AGRARIAN DEVELOPMENT HOLDINGS LTD

LAND SOUTH OF THE A5, HINCKLEY

WALKING, CYCLING AND HORSE-RIDING REVIEW REPORT

project number: ADC1839			report reference: ADC1839-RP-Y
version	date	author	comments
1	13/07/2022	see team statement	review at end of preliminary design stage
2	26/01/2024	see team statement	updated review at end of preliminary design stage

Drq No:	Rev:
ADC1839-DR-007	P5

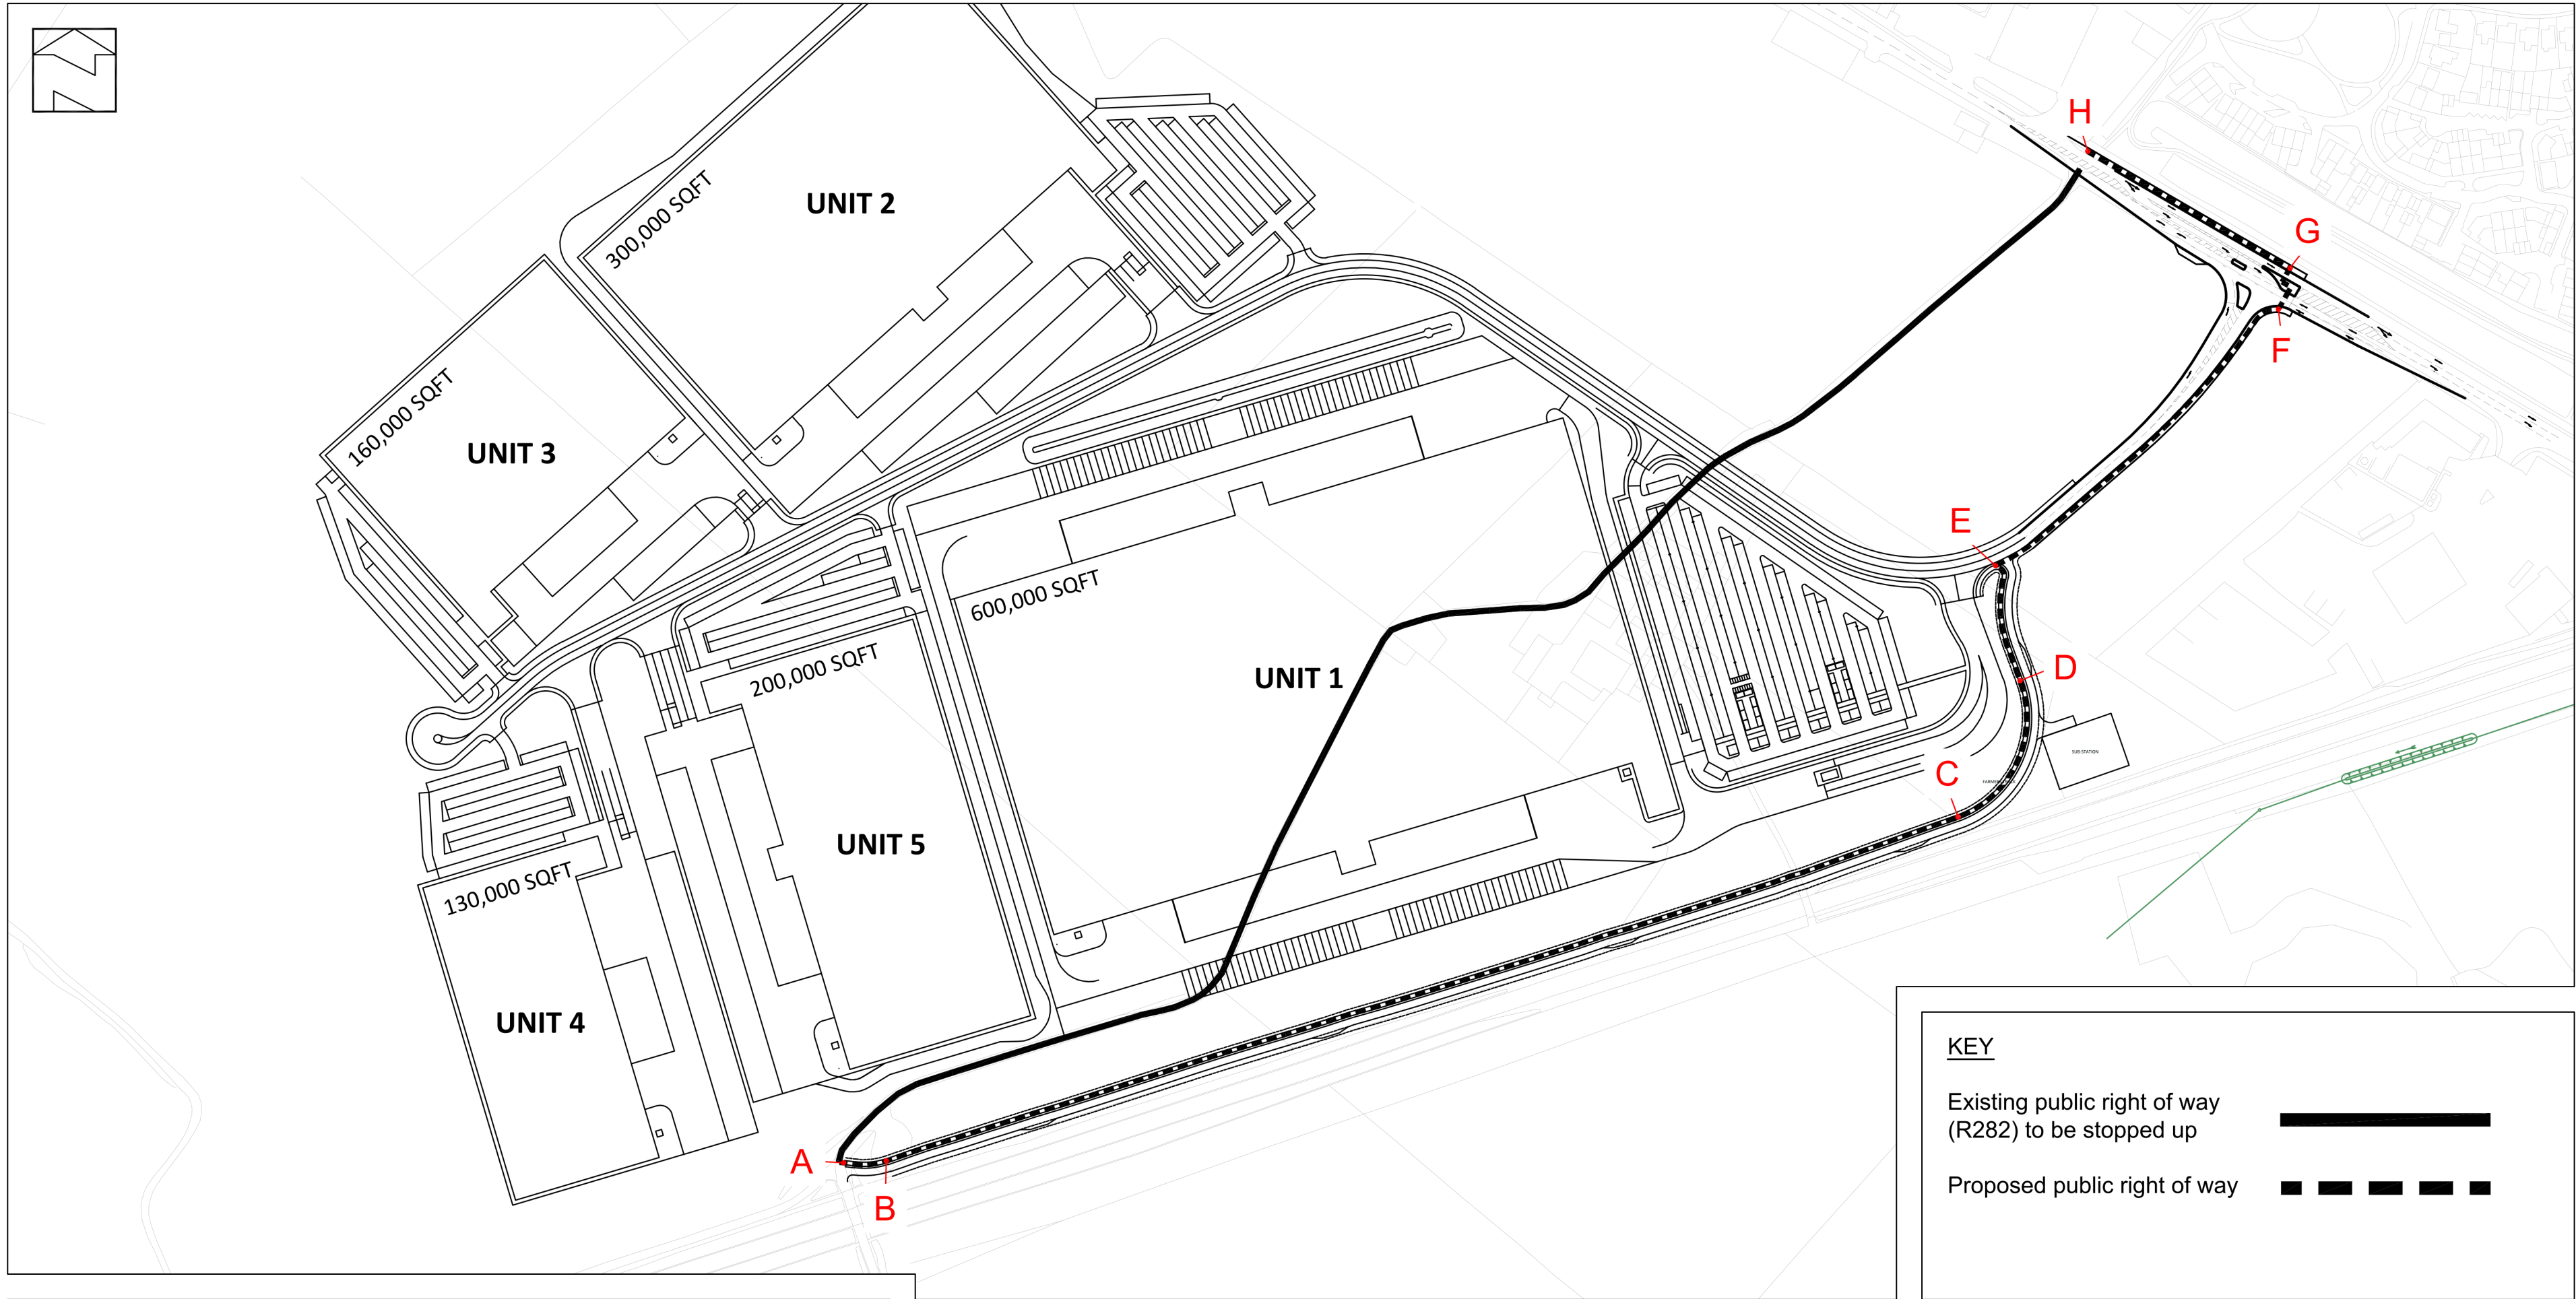
8	Consider crossing facilities on Coventry Road and the A5 Watling Street east arm of Dodwells roundabout to improve the sustainable transport infrastructure.	Considered by not taken forward	This is considered at Appendix A 'A5 Dodwells Roundabout Crossing Assessment'. It is concluded that Development users travelling to and from the east of the site would be able to access the development via the proposed controlled crossing at the site access junction, linking with the B4666 Coventry Road via

Applebees Meadows. The proposed controlled crossing on the A5 (west) arm of Dodwells Roundabout would cater for pedestrian and cyclist demand generated to and from the A5 (west) and A47 Dodwells Road and would provide a suitable (although slightly longer) route for any development users travelling to and from the B4666 Coventry Road via Dodwells Roundabout instead of travelling via the site access junction. Should some development users choose to access the site via the eastern side of Dodwells Roundabout, there would be acceptable gaps in traffic for most able-bodied users to cross the B4666 Coventry Road and the A5 (east) arm using the existing uncontrolled crossing facilities. Users that required longer gaps would be able to use the controlled crossing facilities on the A47 and the proposed controlled crossing on the western side of the junction. There are safety concerns regarding the provision of a controlled crossing on the A5 eastbound exit from Dodwells Roundabout and it has been concluded a controlled crossing should not be implemented. Given these factors, and the alternative provision to be provided on the western side of the junction, it was decided not to provide a controlled crossing on the A5 (east) arm of the junction. Given the very low additional user demand that would be generated by the development and the absence of an existing PIA problem at the B4666 Coventry Road uncontrolled crossing facility, there is not a strong justification for providing a controlled crossing facility on this arm of the junction. To do so may risk encouraging users to cross the B4666 Coventry Road using a controlled crossing facility, to then leave them with crossing the A5 using the existing uncontrolled facility, rather than use the alternative route via the existing controlled crossing facility on the A47 and the proposed controlled crossing on the A5 western arm. Therefore, it was concluded not to provide a controlled crossing on the B4666 Coventry Road arm of the junction. National Highways have confirmed that they are satisfied with this proposal.

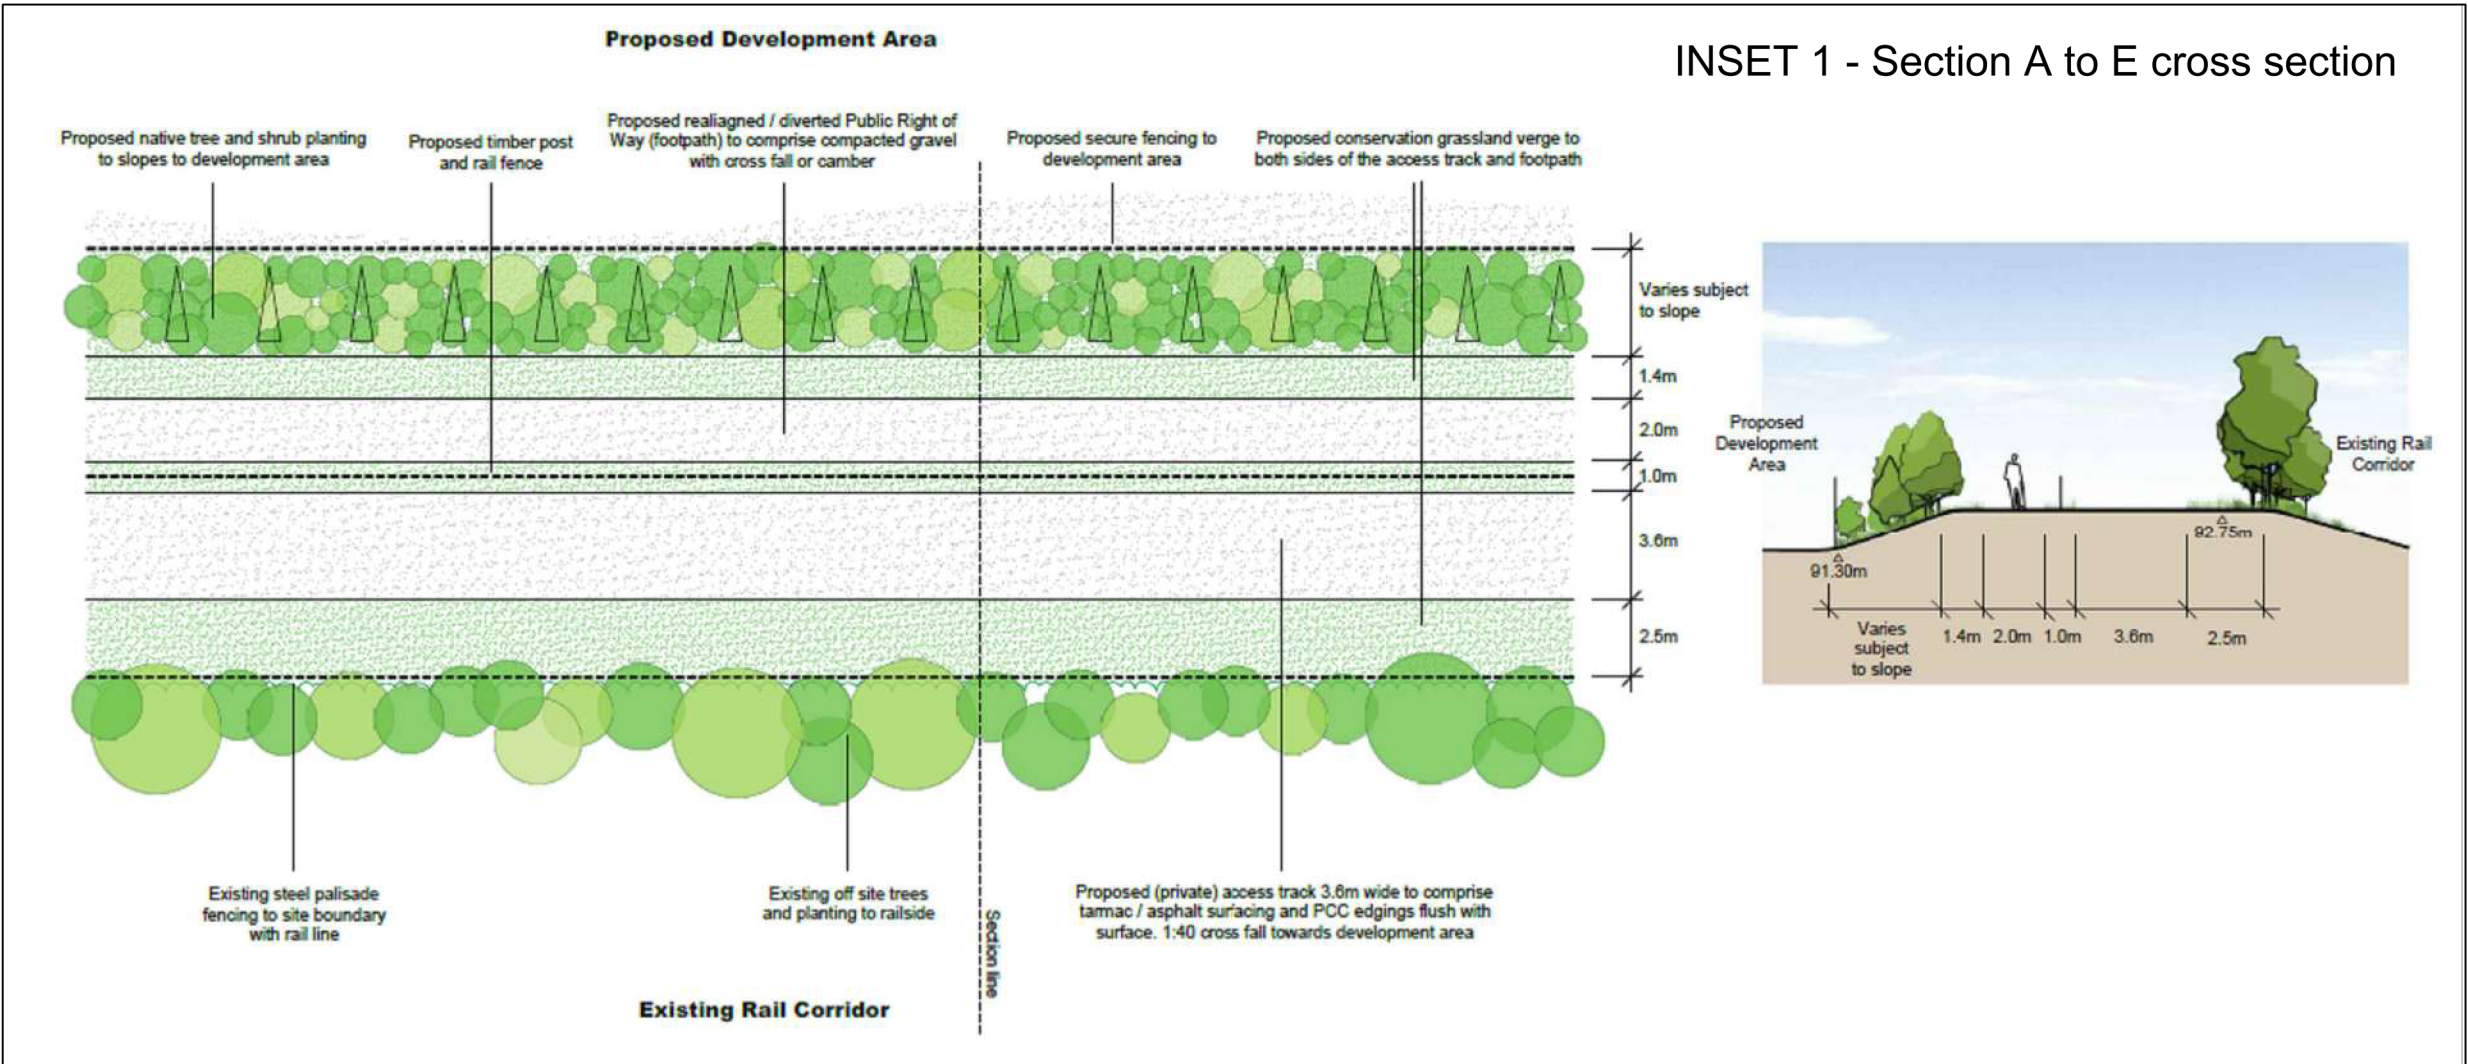
Site, site access and A5 Watling Street			
Ref	Opportunity	Realised?	Review against the preliminary design
2	Divert and extend public footpath R282 to provide a continuous route around the perimeter of the site.	Yes	Drawing ADC1839-DR-011-P4 shows the route of the extended and diverted PRoW R282. This route is also shown in the Parameters Plan.
3	To encourage pedestrian travel, suitable facilities	Yes	Drawing ADC1839-DR-014-P5 shows that a shared footway/cycleway would be provided on
